SUBJECT: REVISION OF SERVICE DIRECTIVE BULLETIN NO. T-014, LANYARD
INSTALLATION FOR TAILCONE VIBRATION ABSORBER

SERVICE DIRECTIVE BULLETIN NO. T-014

Revision 1

1. SUBJECT: Lanyard Installation for Tailcone Vibration Absorber
2. MODEL: TH-28/480
3. EFFECTIVITY: TH-28, S/N 3004 and 3006, and 480, S/N 5001 through 5041, if equipped with the Tailcone Vibration Absorber

Figure 1. Lanyard Installation

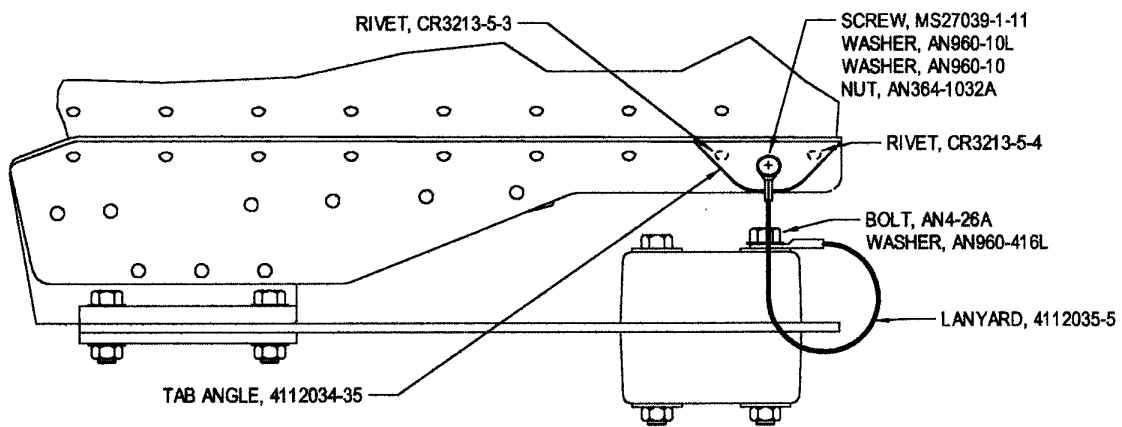
1. Changes the lanyard installation to incorporate an improved lanyard.

A lanyard has been added to the tailcone vibration absorber assembly to prevent damage or injury to property or persons on the ground in the possible event of a vibration absorber failure.

At or before the next 100 Hour/Annual Inspection, install the lanyard on the tailcone vibration absorber in accordance with Figure 1.

1. Remove the existing rivets as indicated in the illustration above.
2. Place the tab angle into position, open the pilot holes as required using a #20 drill, and install the rivets as indicated.
3. Remove the beam assembly from the aircraft. Install the lanyard onto the beam assembly using the AN4-26A bolt with the AN960-416L washer under the head of the bolt. Torque the bolt to 75 in-lbs (8.5 Nm). Reinstall the beam assembly and torque the mounting bolt assemblies to 75 in-lbs (8.5 Nm).
4. Attach the lanyard to the tab angle using the screw, washers, and nut.
